Service-Information Motorcycle

16 016 91
(2486)

Fuel Cap - All Boxer Models

This bulletin replaces S.I. #2244 dated July, 1987

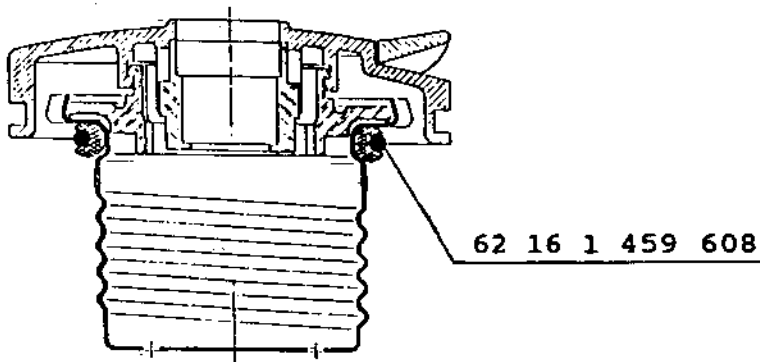
- Condition:** The fuel cap chafes the painted surface of the tank at the filler neck.
- Cause:** The filler neck is welded too deeply into the fuel tank.
- Remedy:** Install an O-ring - part no. 62 16 1 459 608 - into the groove of the fuel cap seal. The O-ring makes the seal slightly thicker and the cap cannot be screwed in as far.
